800 STEWART

EARLY DESIGN GUIDANCE 2

SDCI#3034006-EG

11.05.2019

MASSING EXPLORATIONS

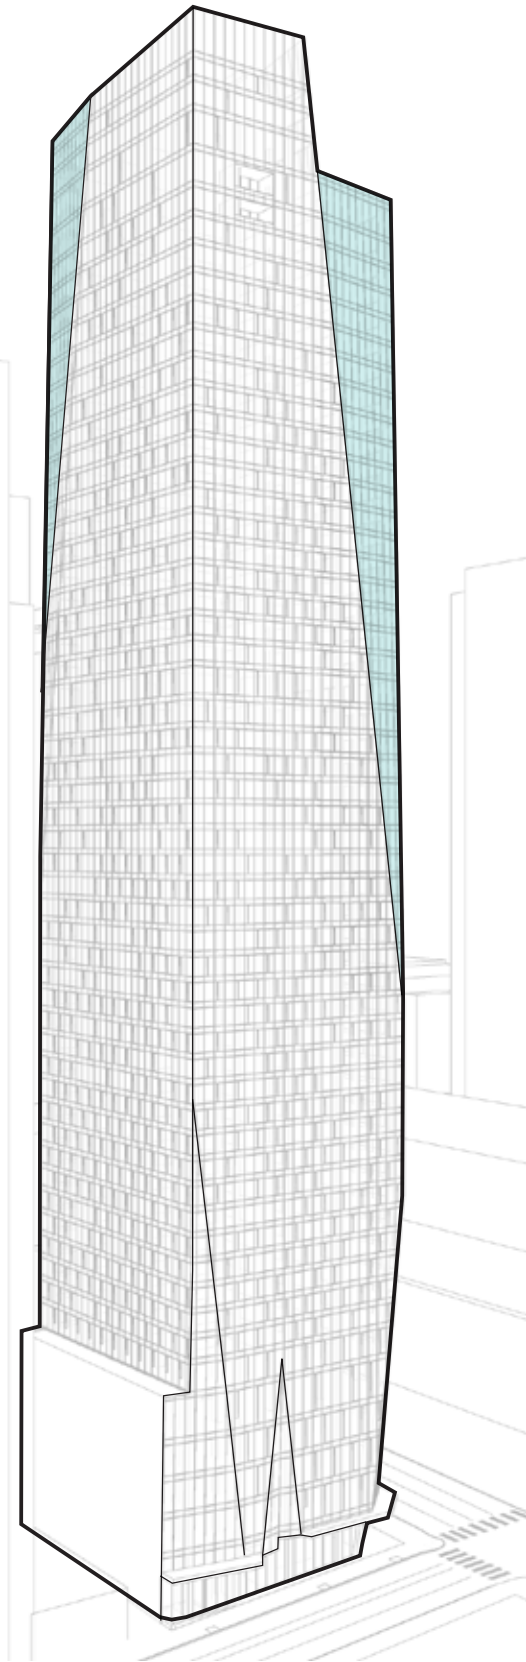
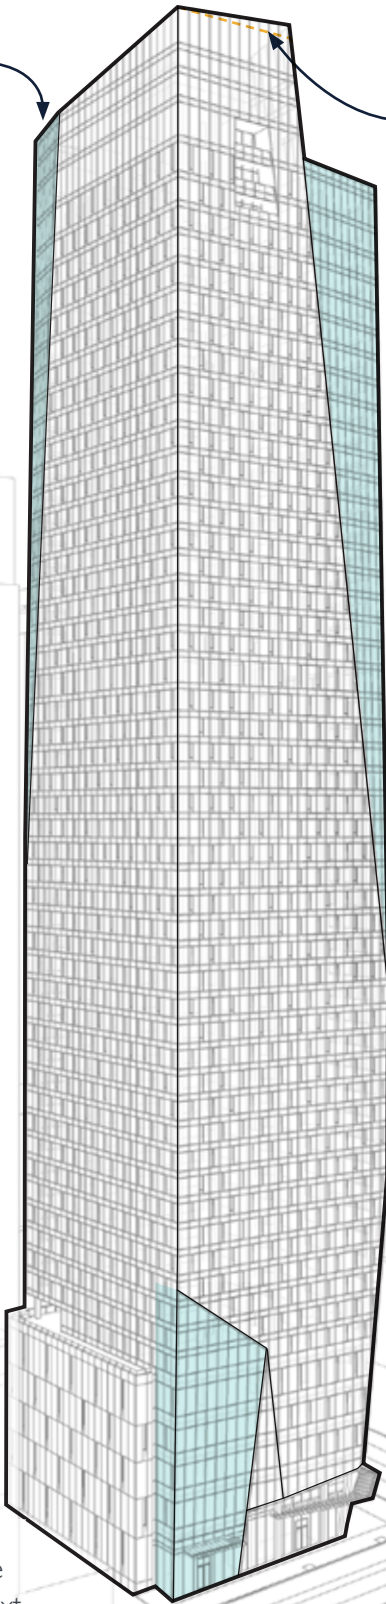
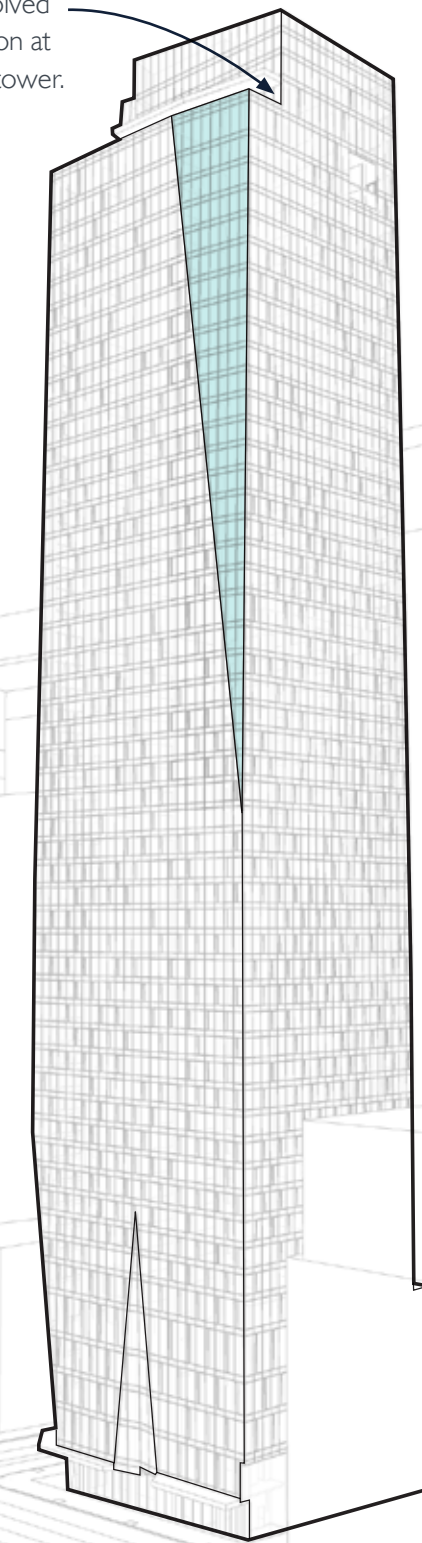
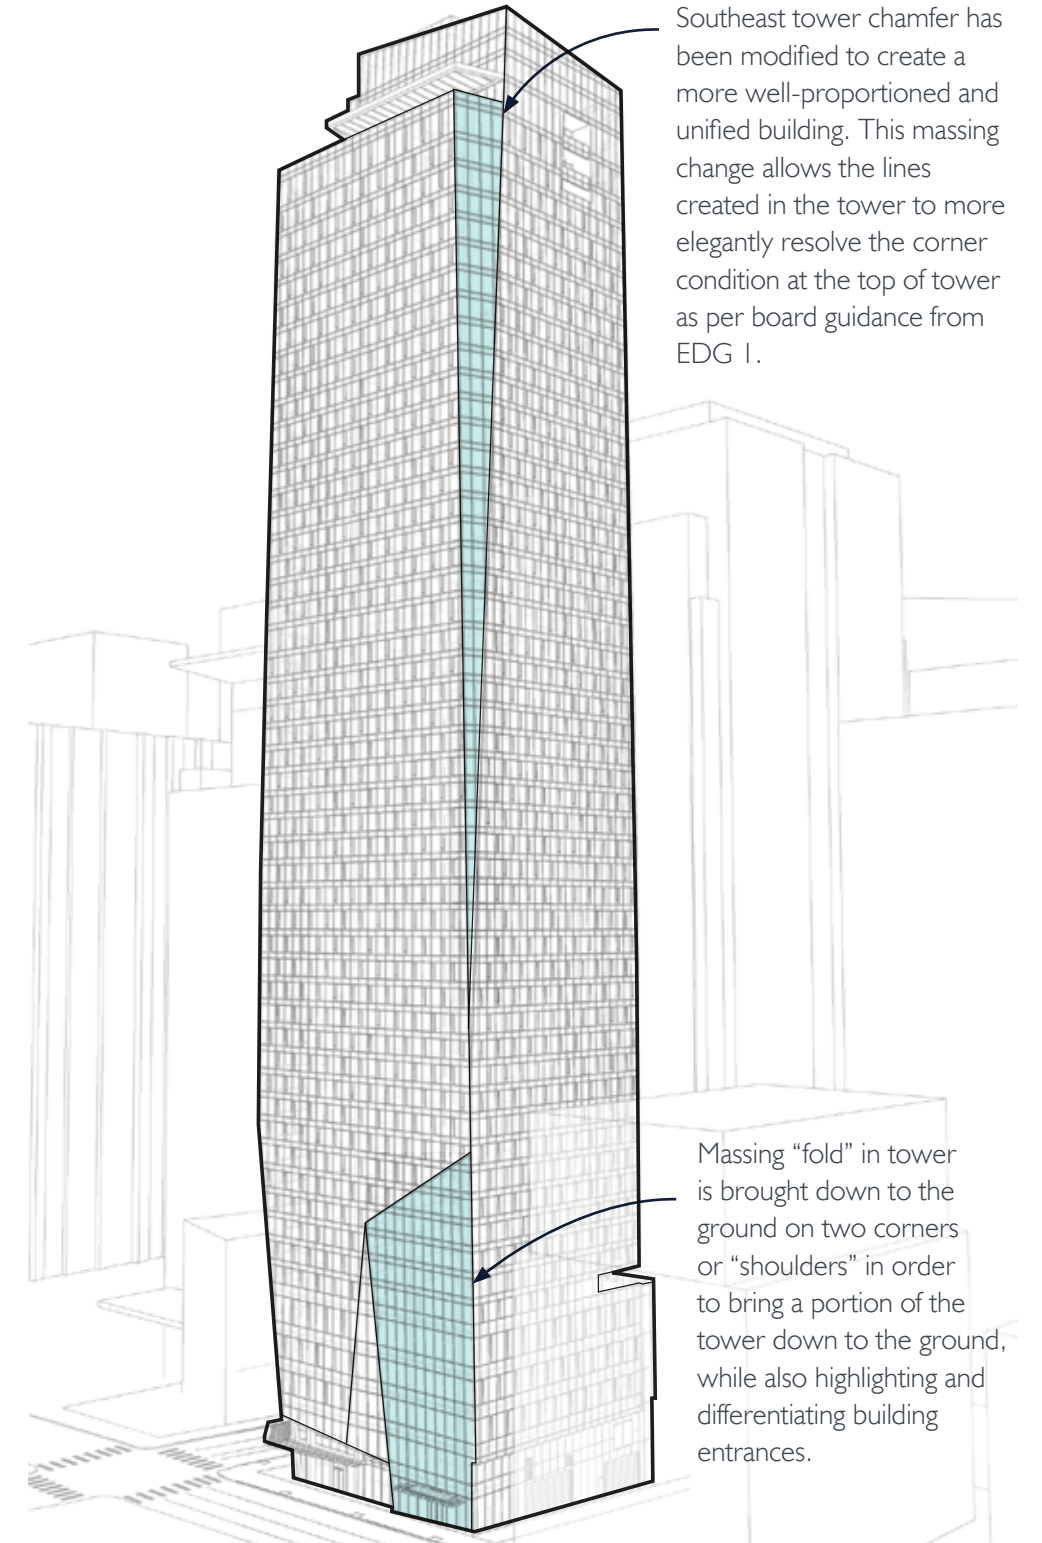
The “Refract” design concept had great potential but that it was only perceptible on the west elevation. The other facades appear conventionally flat and require more development to enhance the skyline and create a unified and well-proportioned design. (A-2, A-1 , B-4)

The Board agreed that there were many approaches to strengthening this design concept that could be successful, and asked the design team to specifically demonstrate responses to the following possibilities at the next EDG meeting: Exploration of the location and size of tower chamfers and folds to increase their visual impact (A-2, B-1)

The design team explored the location, proportion and size of the various chamfers and folds in the tower from all sides of the building. The chamfers have been adjusted in order to further enhance the skyline and create a more unified design. The updated massing also more adequately adheres to the design goals of narrowing the top portion of the tower creating a more pleasant and well-proportioned form as well as providing an elegant resolution at the roof. The design team is also using folds at the base of the tower to bring portions of the massing all the way to grade, further ground the design, and creating a stronger architectural expression at the Southwest corner to respond to the corner condition as well as the adjacent open space at the courthouse. The design team studied the tower massing in situ from various popular viewpoints throughout the city in order to maximize the design impact of the major massing moves.

Elongated and adjusted chamfer to improve visual impact and create a more well-proportioned and unified building design.

Created a more dramatic apex at top of tower in response to board guidance, while further enhancing the skyline.

Ground level is modified in response to neighboring context

PODIUM MASSING RESPONSE DIAGRAM

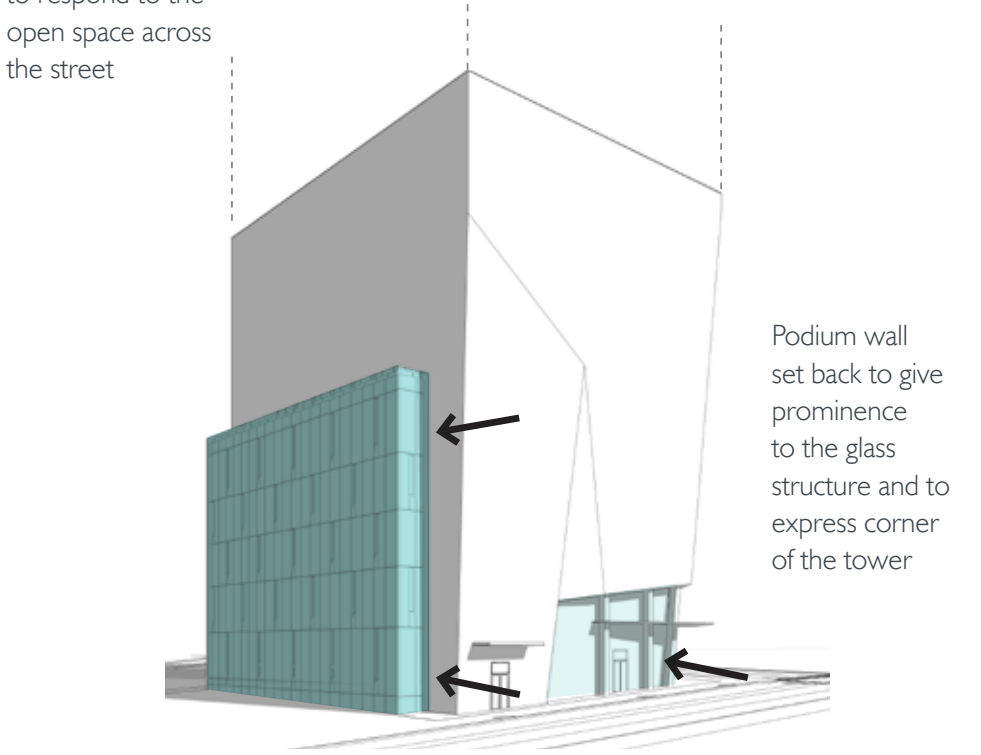
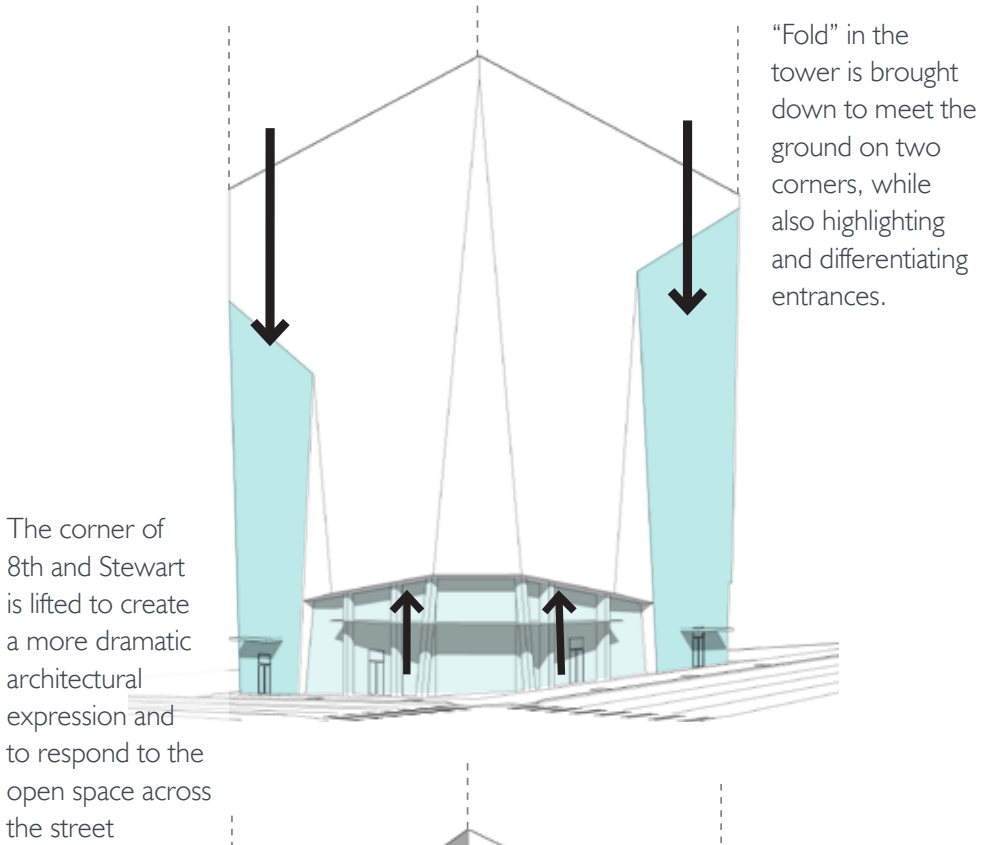
The Board agreed that there were many approaches to strengthening this design concept that could be successful, and asked the design team to specifically demonstrate responses to the following possibilities at the next EDG meeting: Exploration of how the Refract concept could be better integrated with the base, ideally strengthening the expression of both. (B-4, A-1)

The Board agreed that the base expression appeared unresolved and disconnected from the larger design concept and would require further development, with consideration for how this is resolved at the alley. (D-3, C-1, C-2)

The Board noted how the dynamic tower massing in many of the precedents were carried completely down to grade and asked the design team to explore a similar option, ideally with the folds and chamfers from above identifying important programmatic elements at street level. (B-3, B-4)

The design team has modified the design in order to bring the “shoulders”, and deeply inset the tower down to grade, allowing the Southwest corner to be elevated creating a strong architectural expression and urban response. This massing change accomplishes several goals: First it grounds the design by physically bringing a portion of the tower down to the ground. Second it contrasts against the elevated Southwest corner creating a stronger architectural expression. Third it further differentiates and reinforces building entrances and programmatic uses – the massing shifts in plane between residential, retail and office entrances.

The design team also studied the relationship between the major tower massing and the 10’ “podium” on the North end of the site. The design team pushed this secondary massing element back so that the tower form may be more proud and come down to the ground.

Additionally, the design team studied the material expression at the alley and resolved the various material elements in line with the practical need for alley services.

TOP OF TOWER MASSING STUDIES

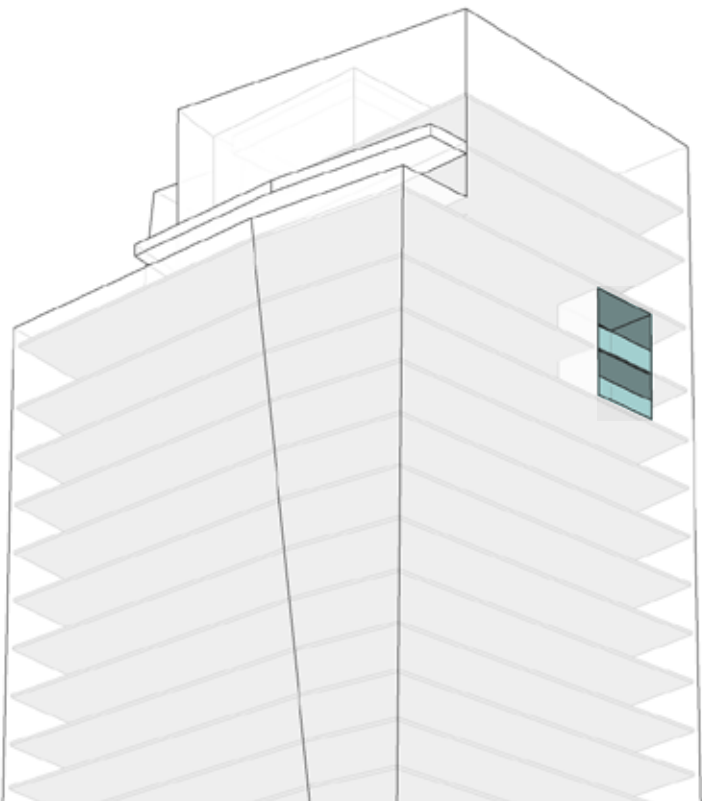
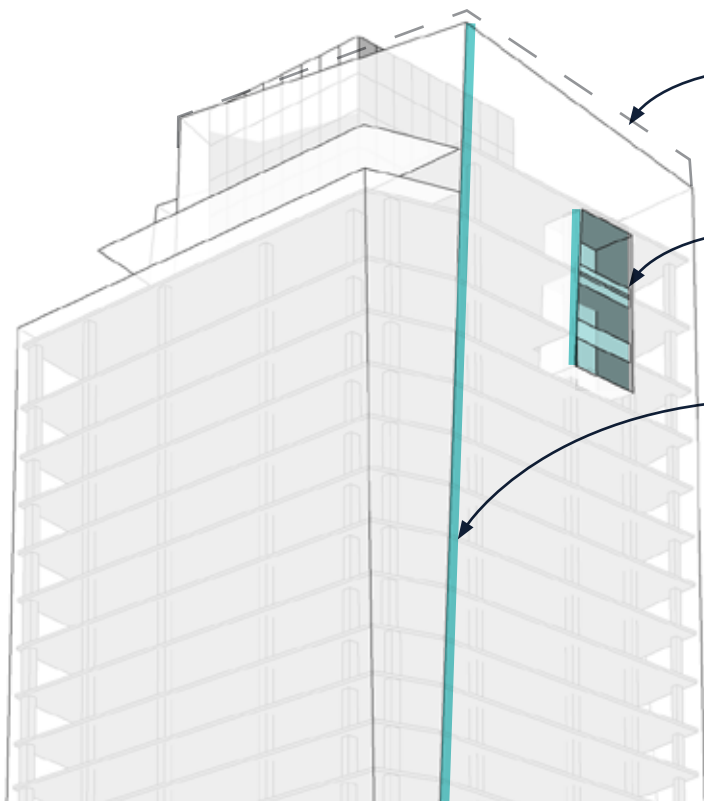
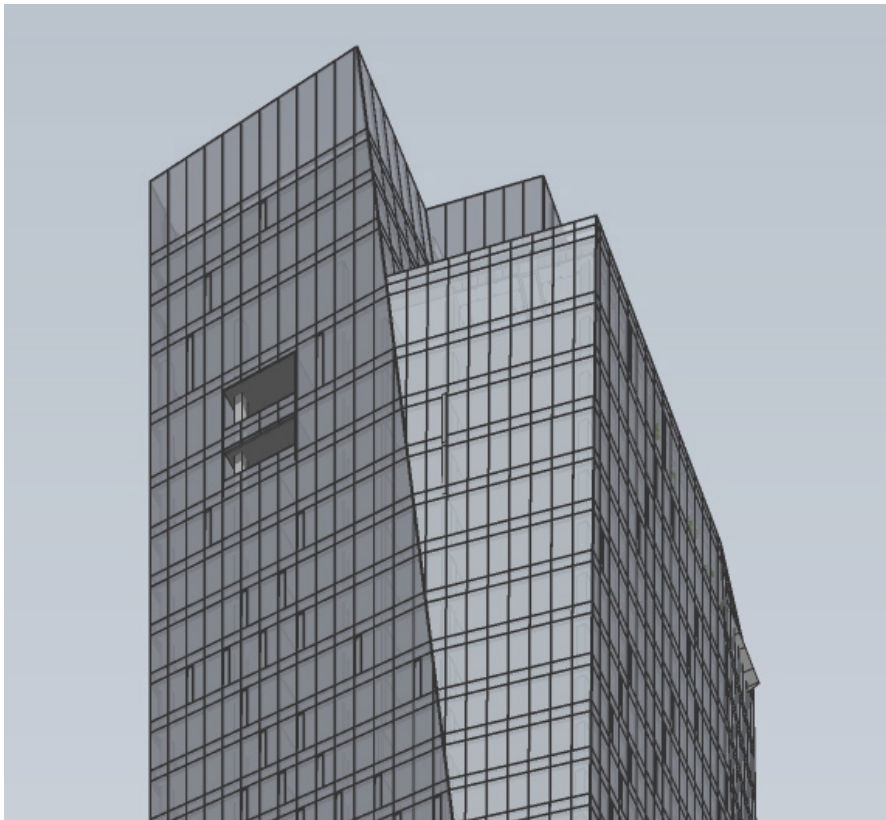
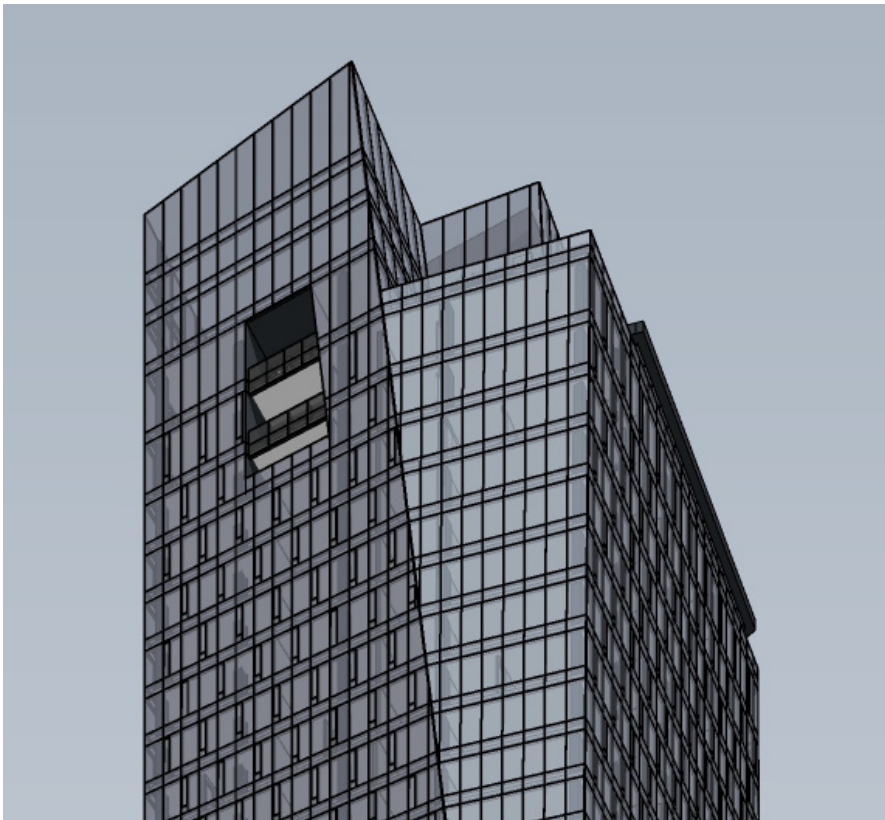
The Board agreed that there were many approaches to strengthening this design concept that could be successful, and asked the design team to specifically demonstrate responses to the following possibilities at the next EDG meeting: The Board agreed that punched openings near the top of the tower were an intriguing design component and asked the applicant to explore further options in their configuration and expression that would strengthen the design concept. (B-4, A-2)

Exploration of a variety of options for the roof, both as a mechanism for strengthening the design concept and as part of a well-proportioned and unified building design. The Board agreed that using the roof form to strengthen the design concept could be particularly important for the relatively weaker elevations. (A-2, B-4)

The design team studied the configuration of the punched openings at the top of the tower. The design has been adjusted so that the side of each opening matches the angle that is created in the massing shifts in the tower, and the proportion of each opening has been heightened to more elegantly respond to the proportion of the overall tower. Lastly, the design team has further refined the material choices in these areas in a more resolved way. All of these changes allow the punched openings to be more integrated in to the overall design of the tower.

Additionally, the design team has adjusted the massing of the tower on select corners so that the top of the tower is more integrated into the overall massing of the tower - eliminating unresolved corners. The design review board commented on the overall success of the resolution at the Southwest corner and the design team has created a similar condition on the Southeast corner in order to more elegantly resolve the massing and enhance the skyline.

Angle of top of tower has been adjusted to increase drama at top of tower and enhance the skyline.

Opening is parallel with the tower chamfer.

Darkening the tint of the glass railing de-emphasizes its appearance in the facade creating a more unified expression.

Angle of top of tower has been adjusted to increase drama at top of tower and enhance the skyline.

Railings are set back from the facade to give definition to the sculptural opening

Massing of corner chamfer adjusted so that the top of tower can be more elegantly resolved.
